| Request   | - | Amendment to Special Use Permit for a school, originally granted by Ord. 631-23                       |
| Location  | - | 6004 Hill Avenue  |

The staff recommends that the Toledo City Plan Commission recommend approval of SUP25-0039, a request for an amendment to a Special Use Permit for a school, originally granted by Ord. 631-23, to the Toledo City Council, for the following **two (2) reasons**:

# ELEVATIONS

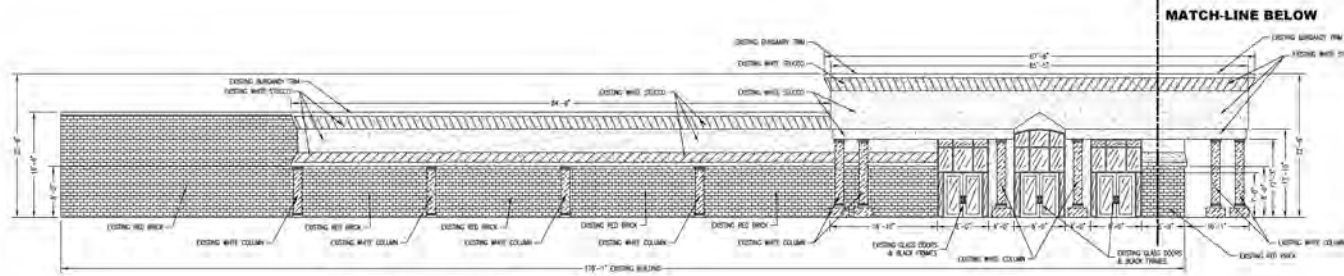
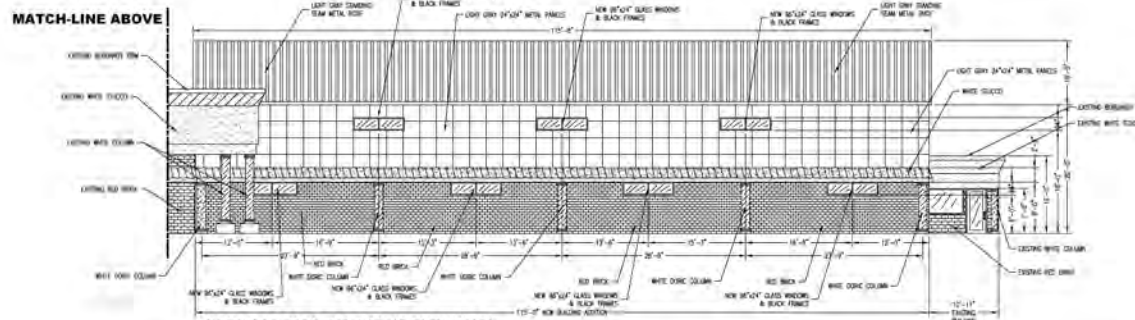
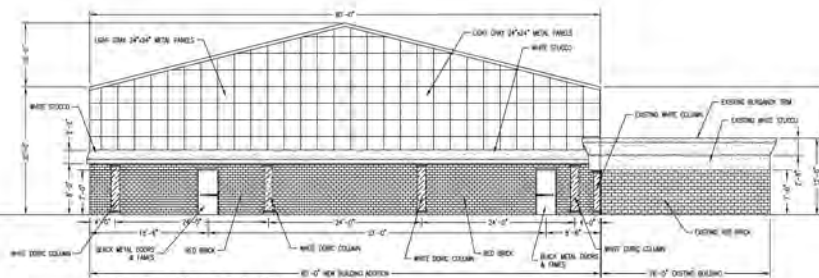
The elevations of the building addition are subject to building material and color standards per TMC§1109.0500 and should match the architecture and style of the existing building. At least eighty percent (80%) of each elevation shall be comprised of predominant building materials and colors; and up to twenty percent (20%) of each elevation may be comprised of accent building materials and colors. The proposed building consists of brick to match the existing, light gray architectural metal panels, with stucco as an accent to match the existing. A light gray standing seam metal roof is proposed, and a condition ensuring the metal roof is not reflective is a condition of approval. The proposed elevations meet the building materials and colors requirement.
